Stantec

Memo

Reference: RM25.372 Parkburn, Compliance review of EMP

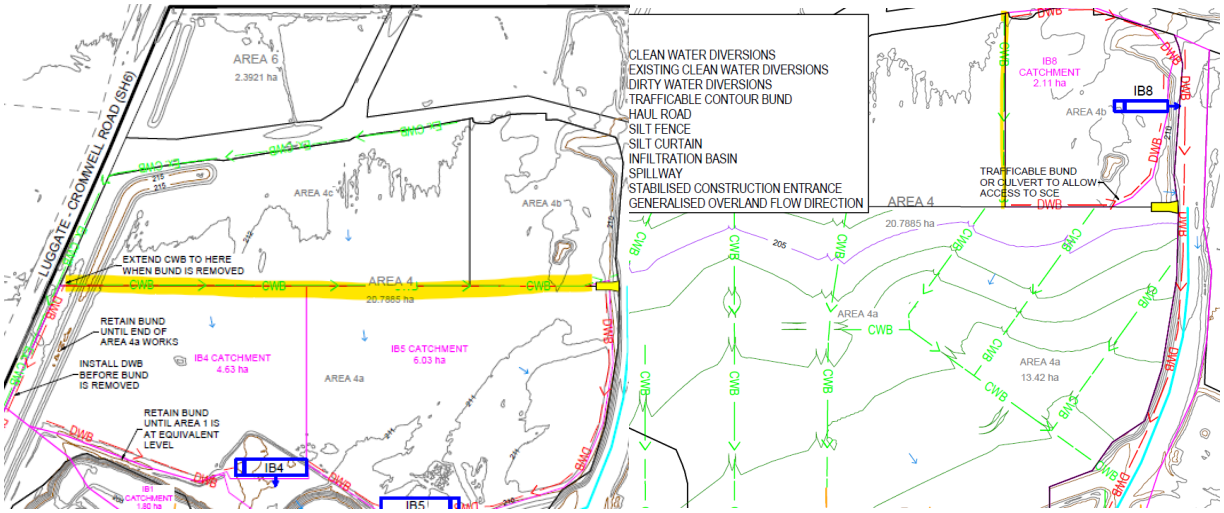
Furthermore, the design of the infiltration basins have no factor of safety. GD07 outlines what factors of safety should be applied for different situations where soakage could be affected by factors like insufficient pretreatment (i.e. sediment build up), difficulty to access, insufficient confidence in the soakage testing (distance from the pipe the test), frequency of maintenance. Infiltration basins will have lower factors of safety when following the GD07 testing and design requirements, but this should still be followed and state why each safety factor was used.

The limited testing, absence of stated safety factors, and uncertain basin geometry may result in undersized or inefficient infiltration basins, creating a material risk of water management failure, environmental incidents, or inoperable soakage devices.

3. Incorporate GD07 factors of safety to account for sedimentation, seasonal reduction in soakage, groundwater level effects, and uncertainty in soakage testing.
